Progress Energy

Serial: NPD-NRC-2009-242
December 14, 2009

**LEVY NUCLEAR PLANT, UNITS 1 AND 2
DOCKET NOS. 52-029 AND 52-030
RESPONSE TO SUPPLEMENTAL REQUEST FOR ADDITIONAL INFORMATION REGARDING
THE ENVIRONMENTAL REVIEW**

Levy Nuclear Plant Units 1 and 2
Response to NRC Supplemental Request for Additional Information Regarding the
Environmental Review for the Combined License Application, dated September 25, 2009

Figure 9.3-7-1 – Levy 2 / LNP Site Locations

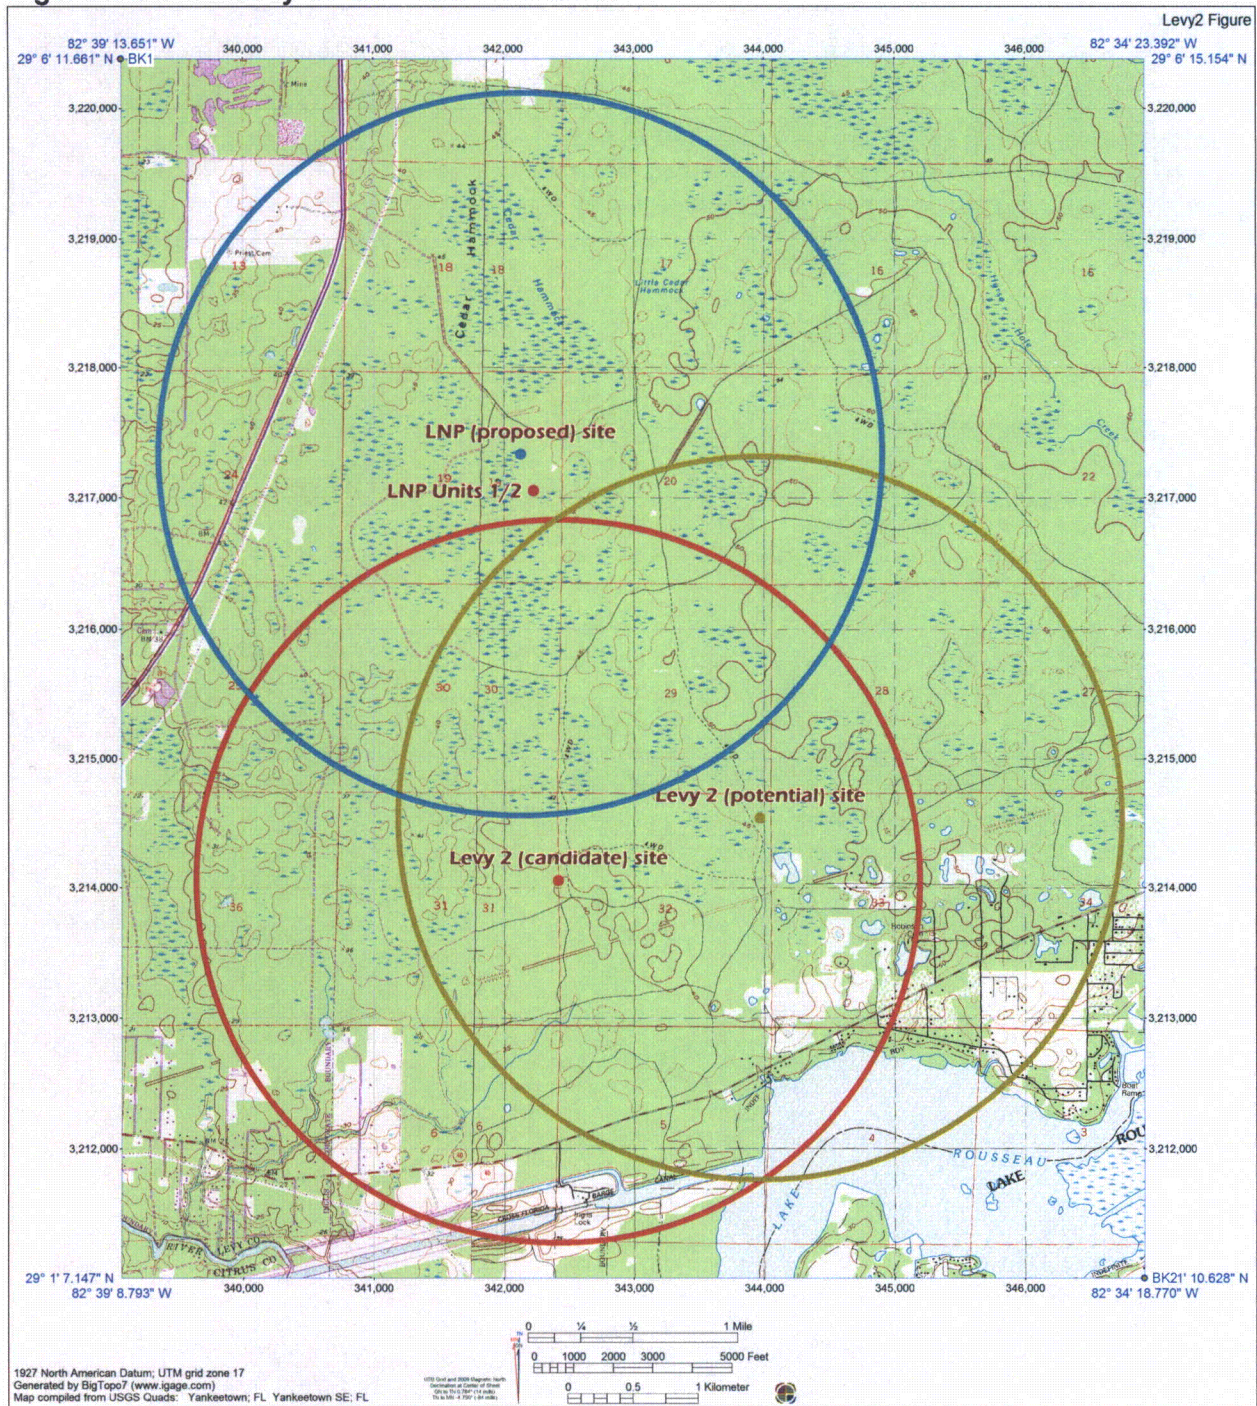
Text of NRC RAI: Clarify the boundaries of the Levy 2 site as reported in the EFS and ER.

Aerial photos in the unredacted version of the EFS (Appendix A, page 10 of 22) suggest that the geographical location for the Levy 2 site (i.e., the preferred LNP site analyzed in the ER) is not consistent with the location of the LNP site as presented in the ER. Provide clarification.

The EFS siting process allows for optimization of sites as the process is executed and additional information is gathered. The LNP site was optimized during the siting process. Figure 9.3-7-1 depicts the geographic locations of the Levy 2 potential site, the Levy 2 candidate site, and the LNP site, as the site was slightly relocated to optimize or respond to siting considerations and findings from the analysis at various stages of the process. The Levy 2 (potential) site is the originally selected site (EFS Appendix IV, Section 4.0) as evaluated in the screening criteria evaluation of potential sites (EFS Appendix IV, Section 5.0). The Levy 2 (candidate) site is the relocated site as optimized based on aerial overflights and additional research and is evaluated in the general site criteria evaluation (EFS Section 6.0). The LNP site is the proposed site location as ultimately acquired and analyzed in the ER. The center point of the two LNP units is also depicted on the attached figure. The circles represent the 6,000-acre areas analyzed in the siting study.
